This is an ODOT let project. The project name in the plans shall match the project name in Ellis:
BUT GMR Trail Middletown-Monroe

GREAT MIAMI RIVER TRAIL

COVER SHEET	P.1
SCHEMATIC PLAN	P.2
TYPICAL SECTIONS	P.3
GENERAL NOTES	P.4
GENERAL SUMMARY	P.5
PLAN AND PROFILE	P.6-P.24
CROSS SECTIONS	P.25-P.69

119064

P.2

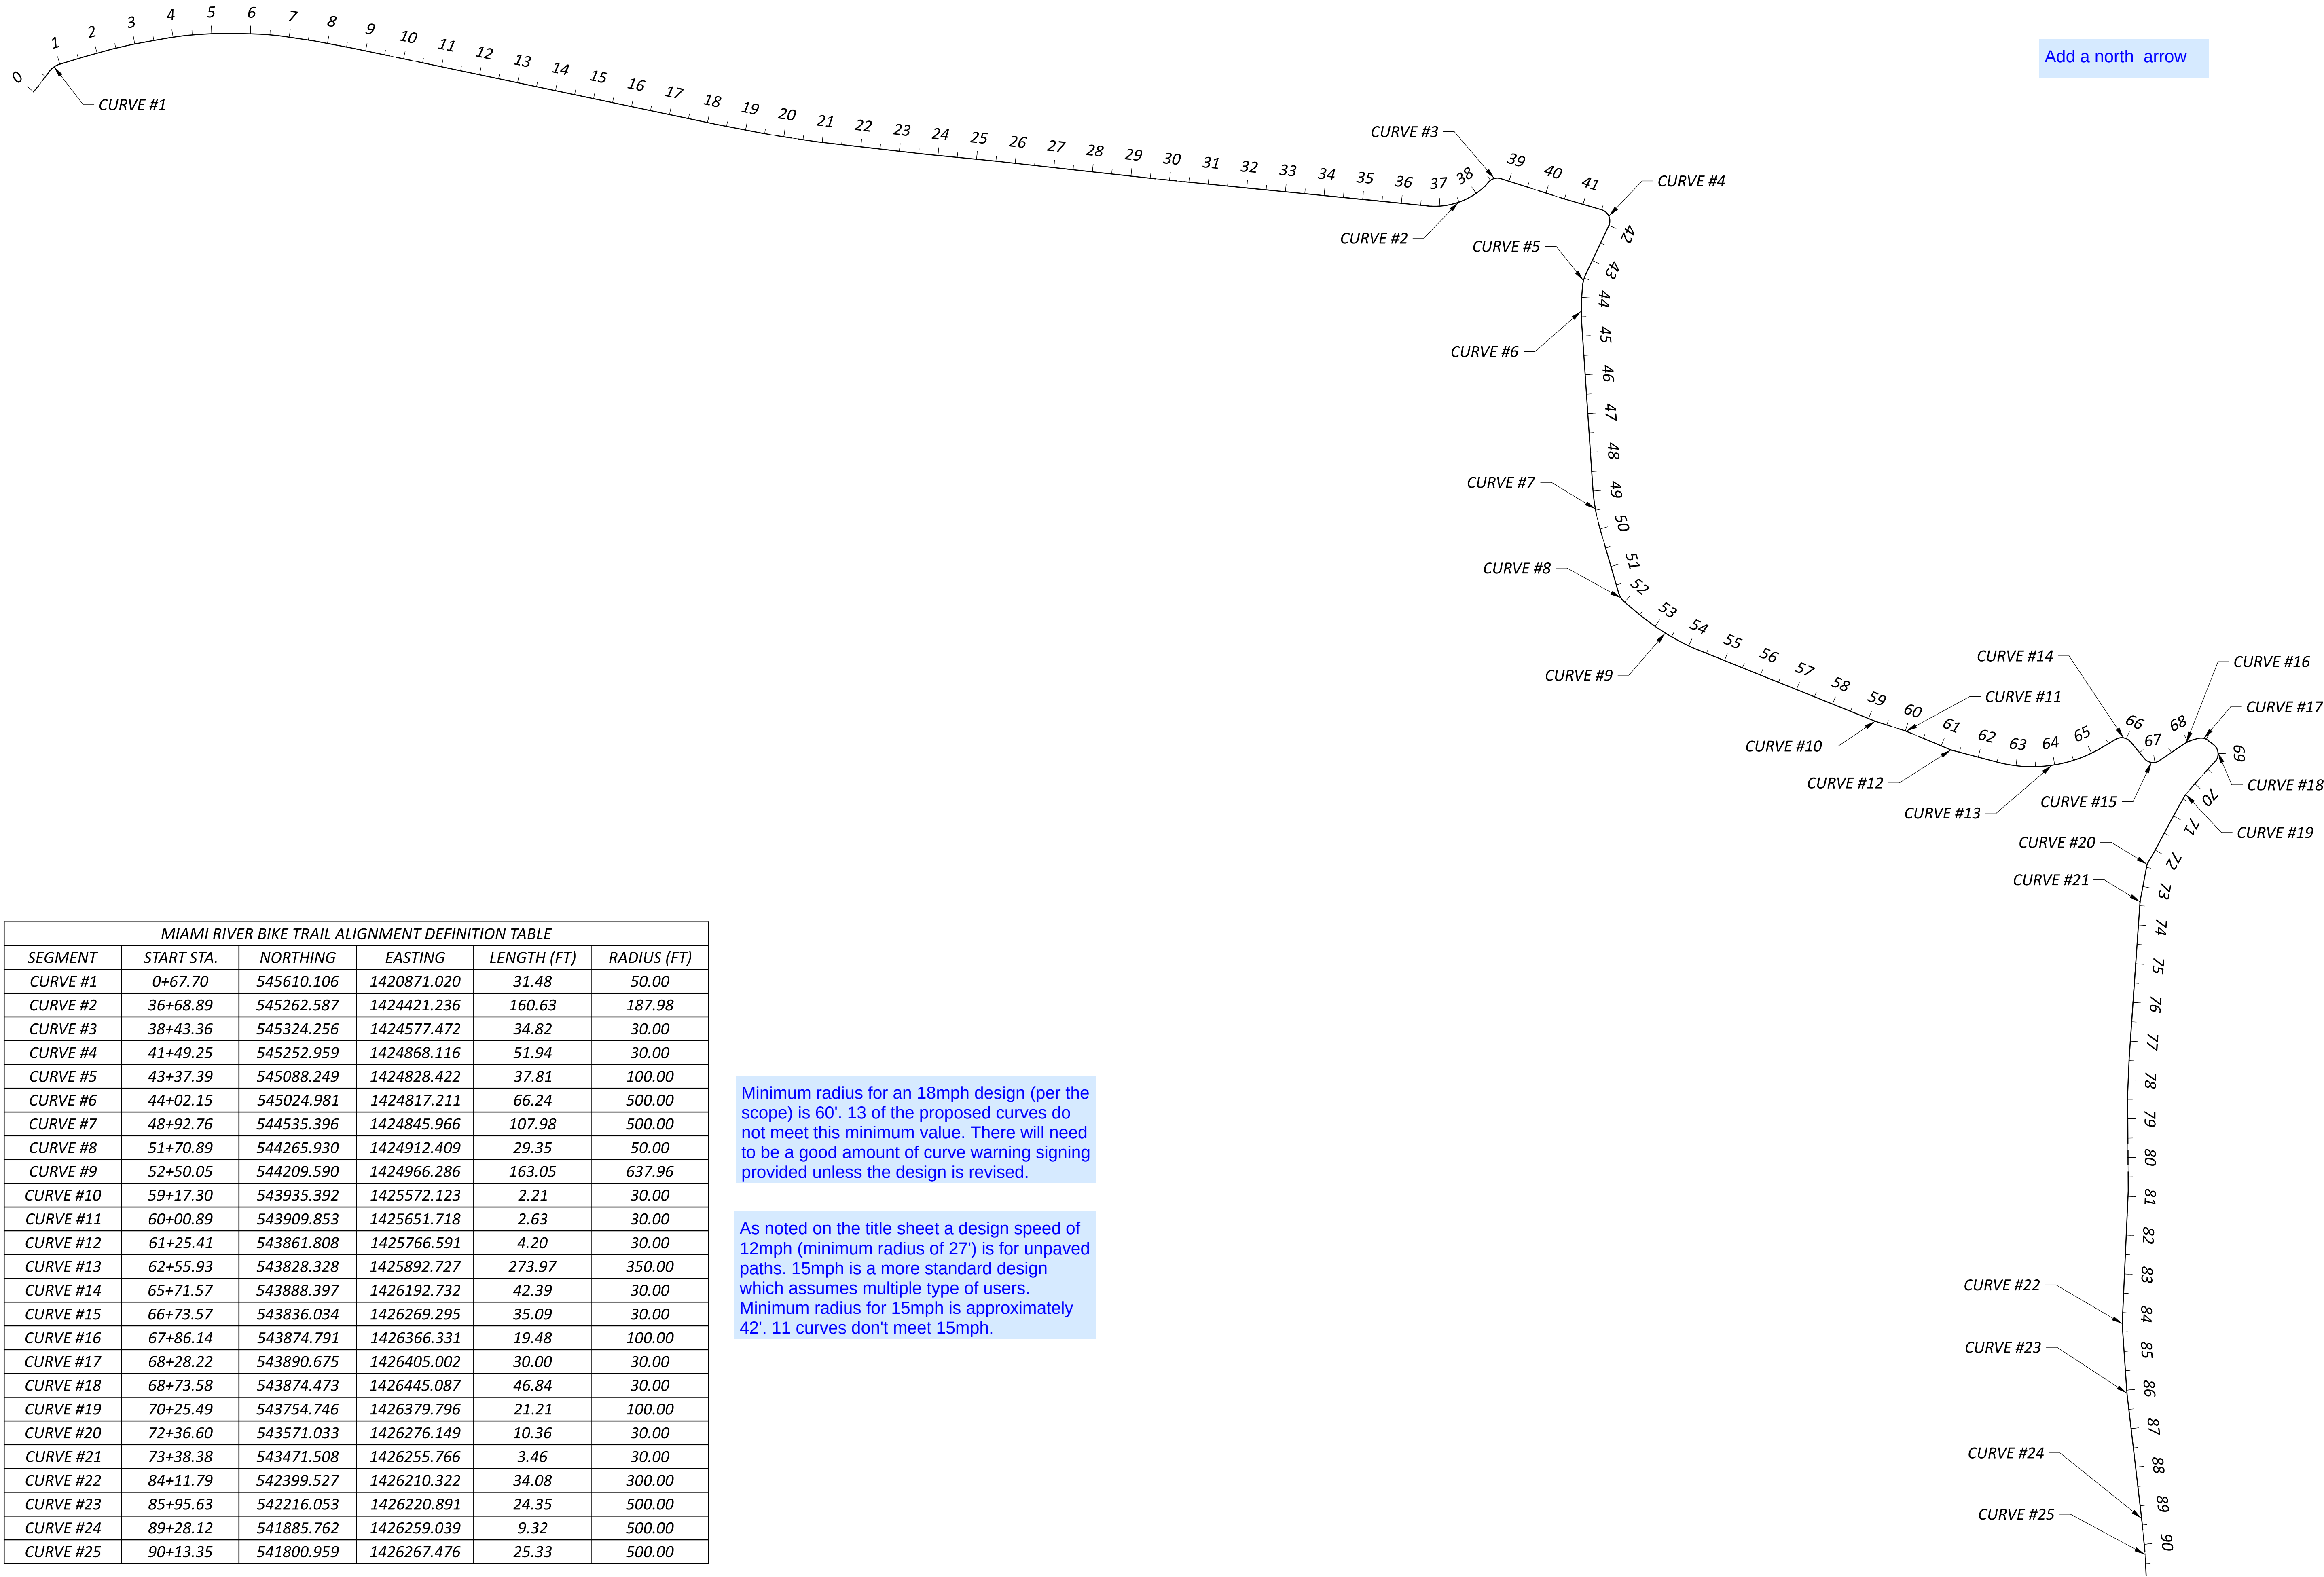
Minimum radius for an 18mph design (per the scope) is 60'. 13 of the proposed curves do not meet this minimum value. There will need to be a good amount of curve warning signing provided unless the design is revised.

As noted on the title sheet a design speed of 12mph (minimum radius of 27') is for unpaved paths. 15mph is a more standard design which assumes multiple type of users. Minimum radius for 15mph is approximately 42'. 11 curves don't meet 15mph.

P.6

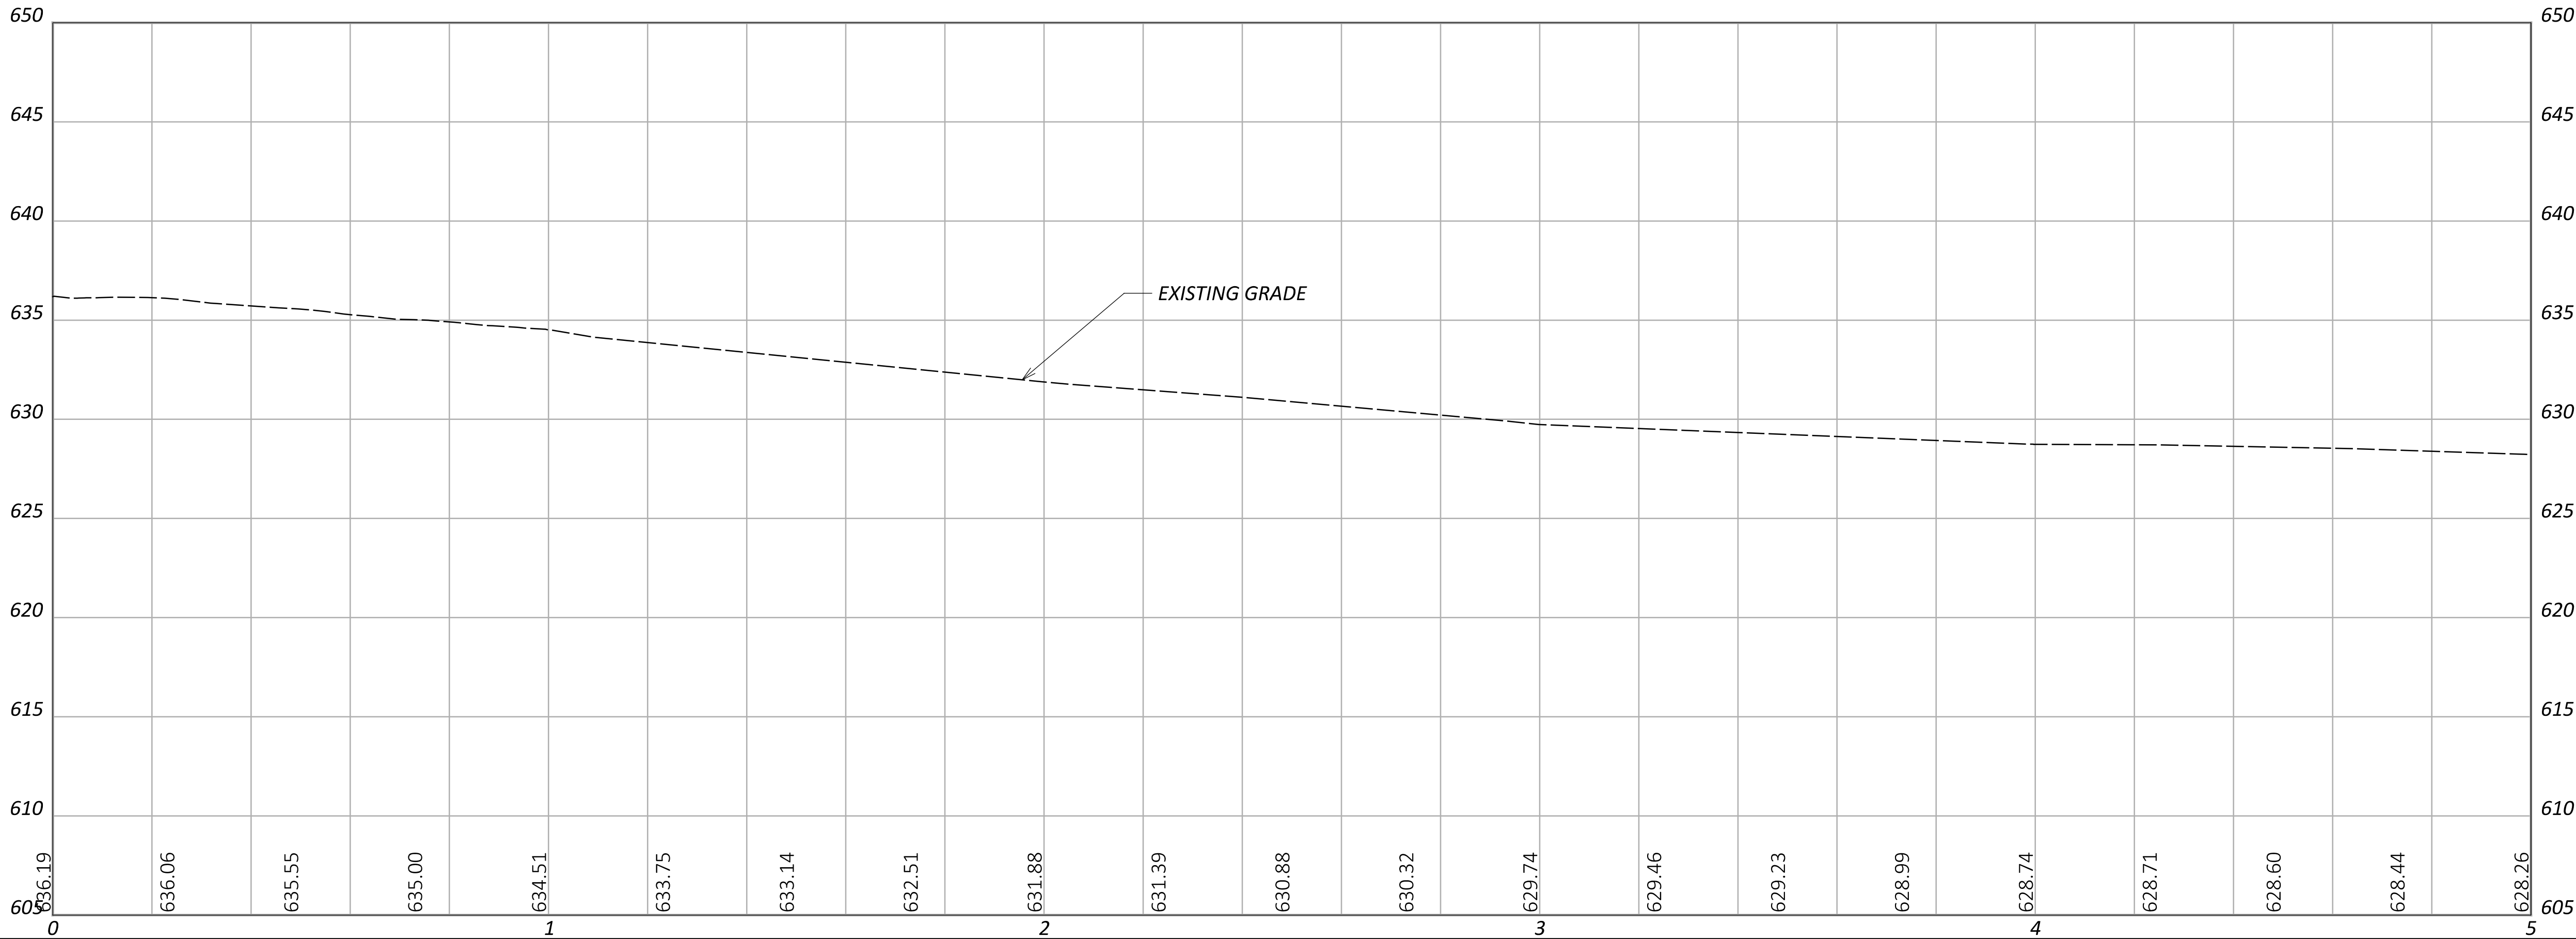
If this is a 2-way path on the southern shoulder, striping and other separation is needed from vehicle traffic. Is the existing pavement wide enough? It doesn't look like there is a paved shoulder on Oxford State Rd Where is the signing plan? This needs to be provided at the next submission
